Docket Number:	19-OIR-01
Project Title:	Load Management Rulemaking
TN #:	237403
Document Title:	Polaris Energy Services comments on Load Management Standards Draft Analysis
Description:	N/A
Filer:	System
Organization:	Polaris Energy Services
Submitter Role:	Public
Submission Date:	4/9/2021 1:03:43 PM
Docketed Date:	4/9/2021

Polaris Energy Services comments on Load Management Standards Draft Analysis

Polaris Energy Services Comments on Load Management Standards Draft Analysis

Figure 3-9. The Shift resource available in forecast year 2030 at the BTM battery price referent (\$150/yr/kWh), disaggregated by utility service territory, building type, and end use.

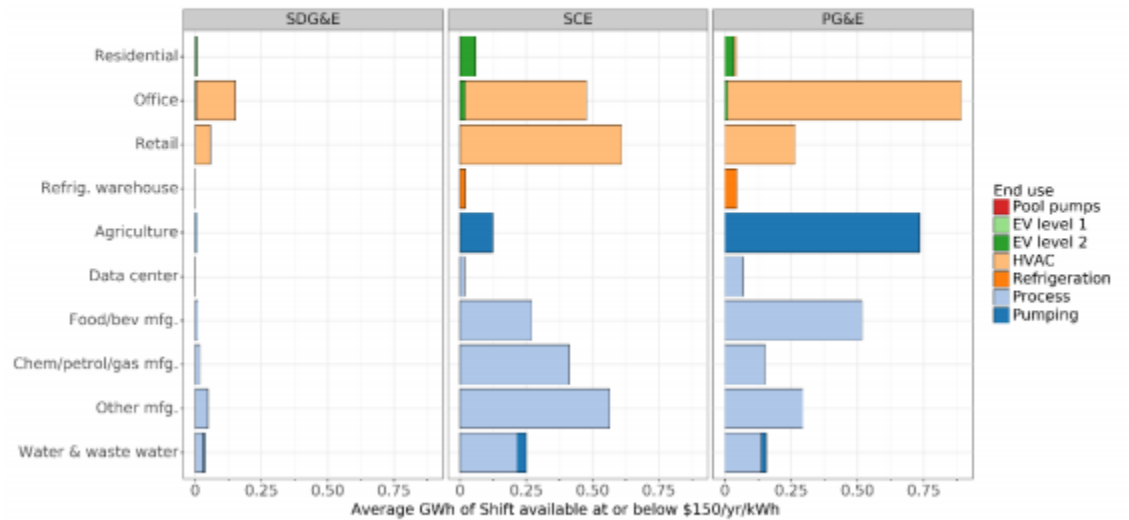
- My pet peeve - look for the load where it is available. The analysis contains 12 mentions of water heaters, 26 of cooling and 34 of thermostats, 0 mentions of irrigation pumping, and 1 mention of pumping (other than the name of SCE's program), yet this is LBNL's assessment of load shift potential by end use. If they are right, we should stop focusing so much on residential load and more on Ag and office.
